**PLEASANT PRAIRIE PLAN COMMISSION MEETING
VILLAGE HALL AUDITORIUM
9915 39th AVENUE
PLEASANT PRAIRIE, WISCONSIN
6:00 P.M.
April 17, 2018
AGENDA**

VILLAGE STAFF REPORT OF APRIL 17, 2018

SUBJ: Haribo of America – Concept Plan

VOPP ENG REVIEW PLAN-MARK UP MARCH 12, 2018

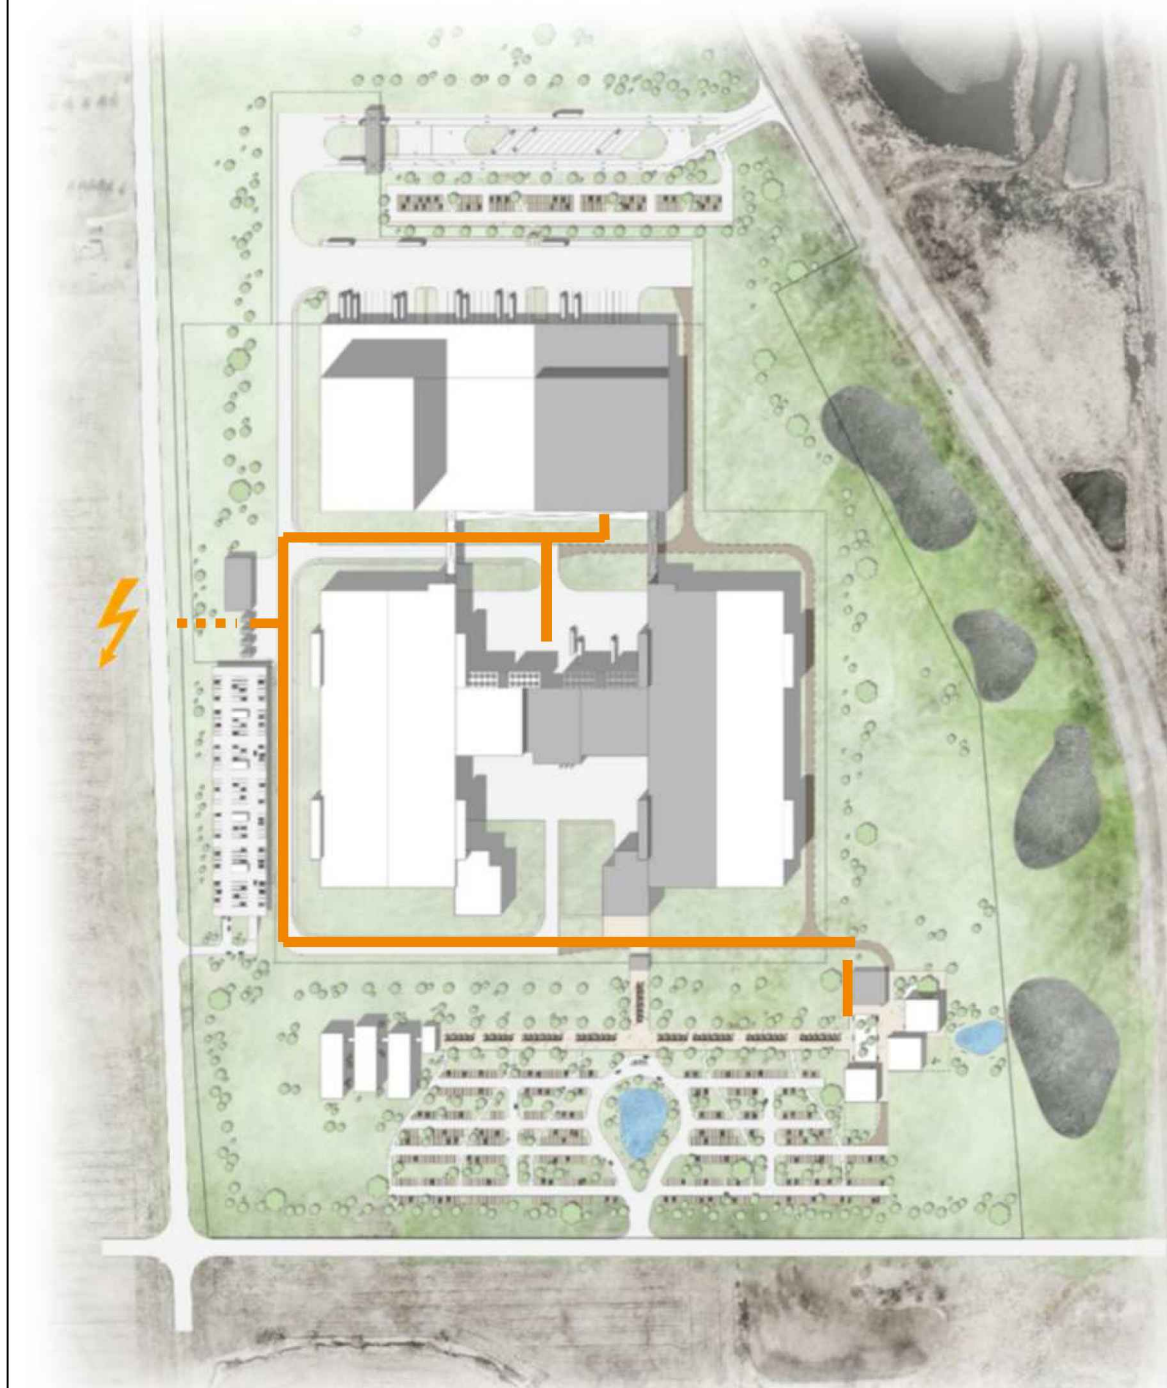
HARIBO TO COORDINATE WITH WE-ENERGIES

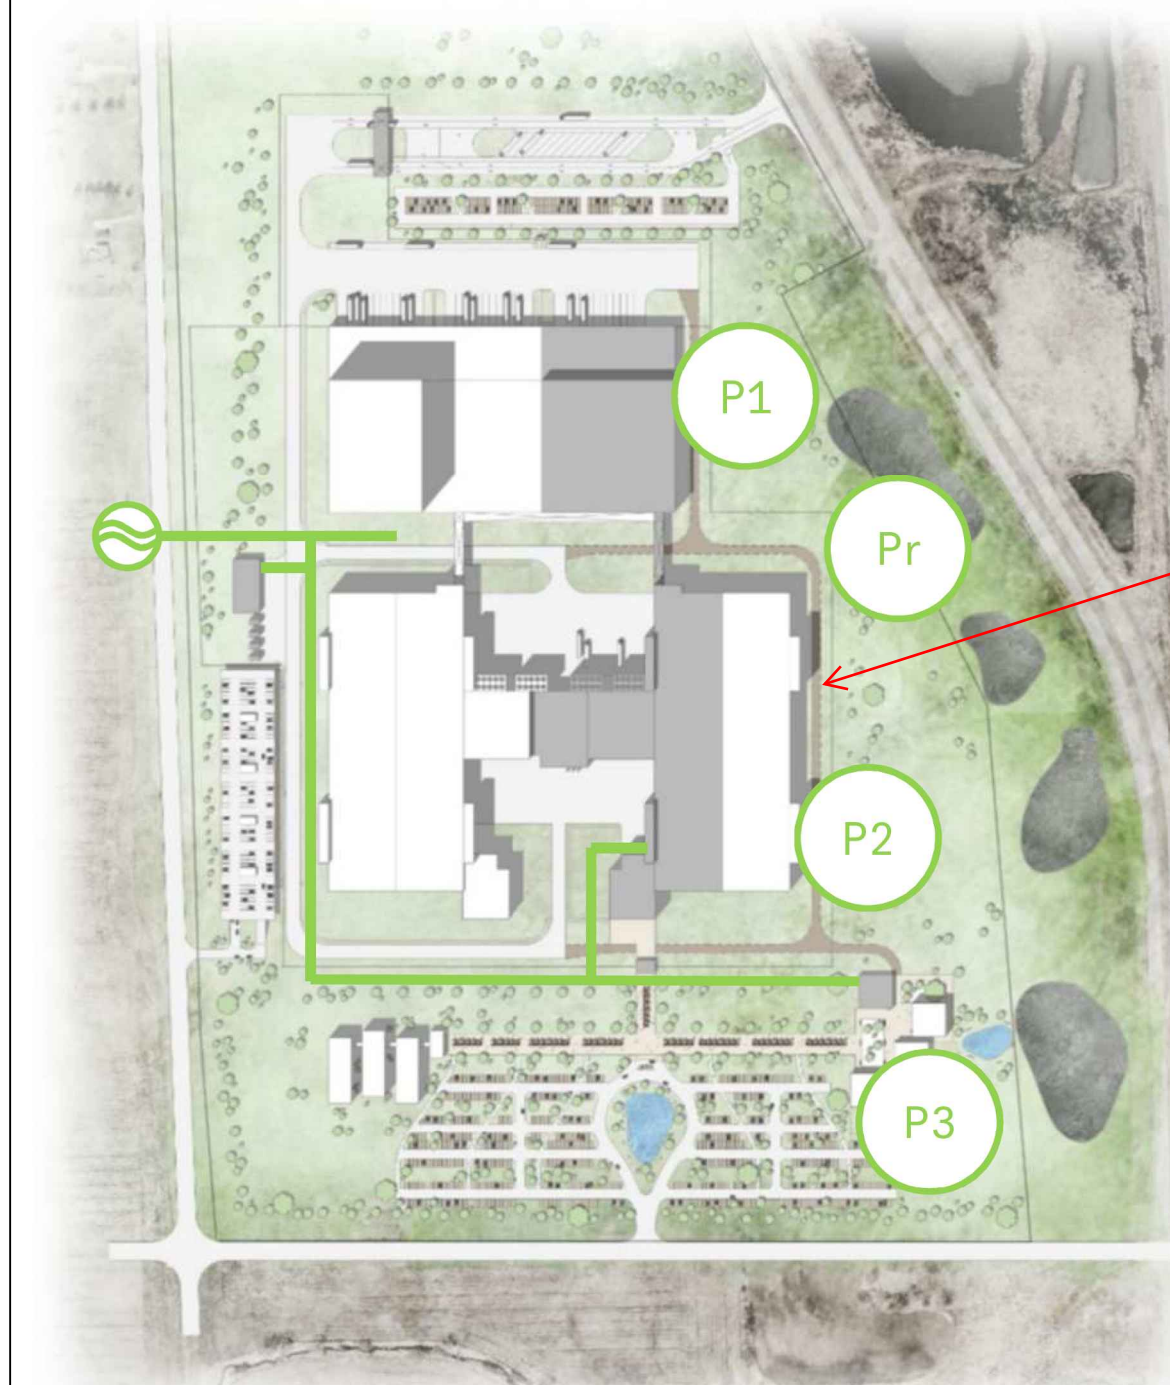
DESIGN WILL NEED TO TAKE
INTERNAL LOOPING AND
FIRE HYDRANT SPACING
INTO ACCOUNT

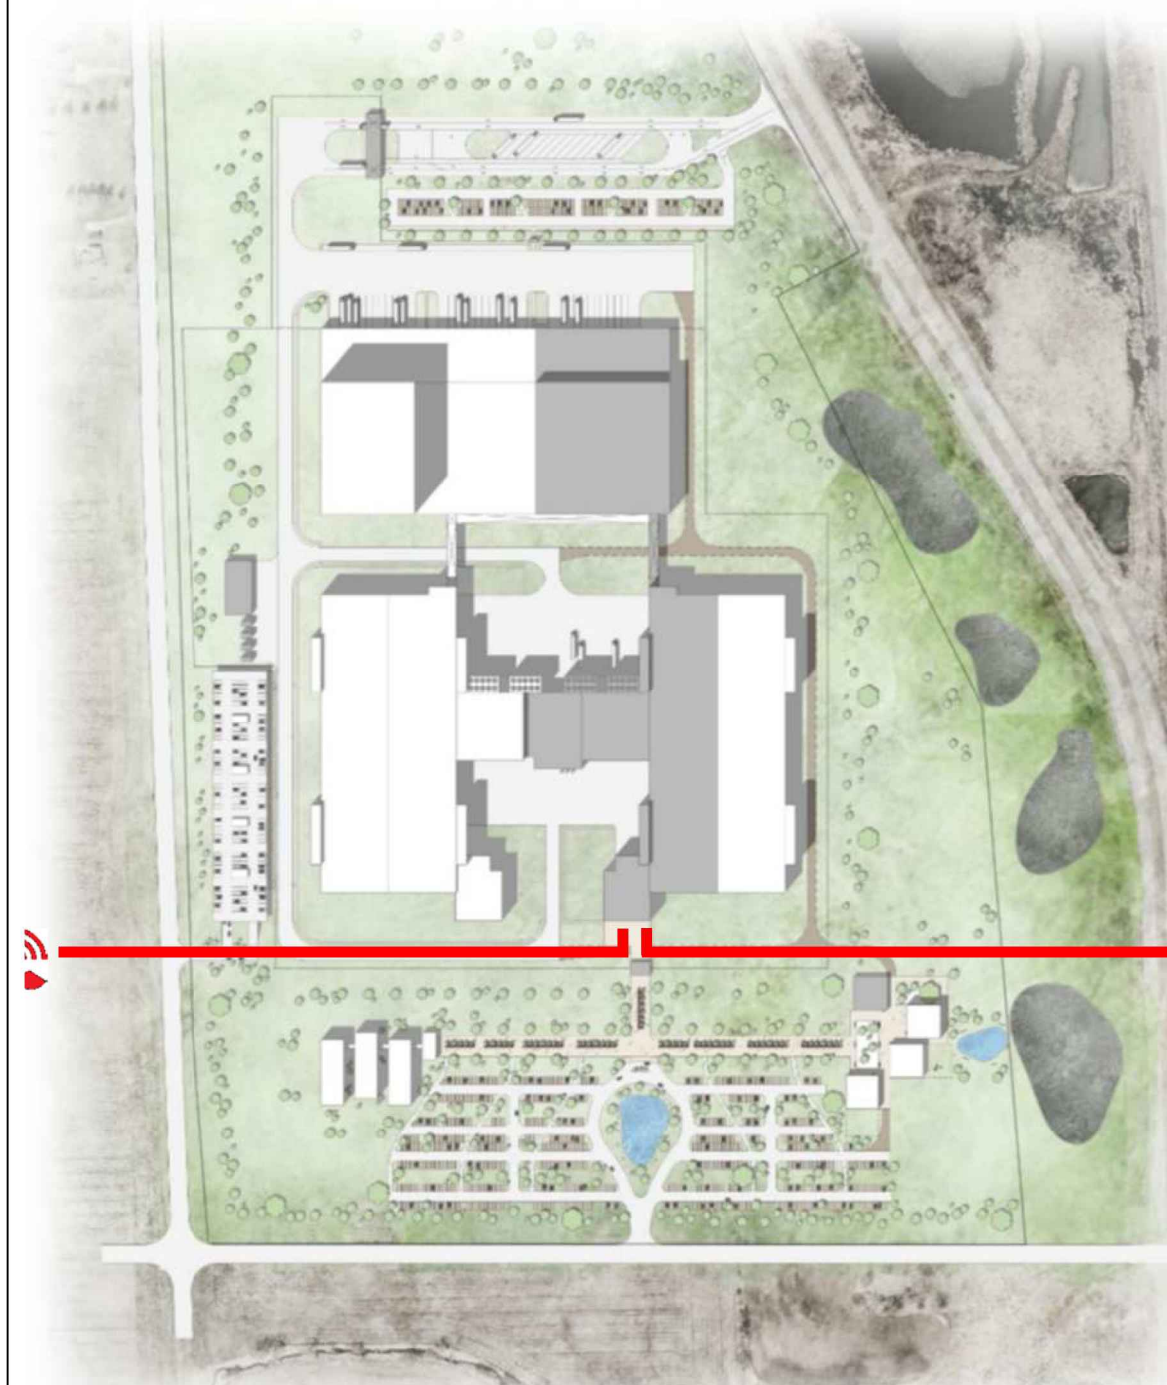
HARIBO TO COORDINATE WITH
RESPECTIVE PRIVATE UTILITY
SERVICE COMPANIES.
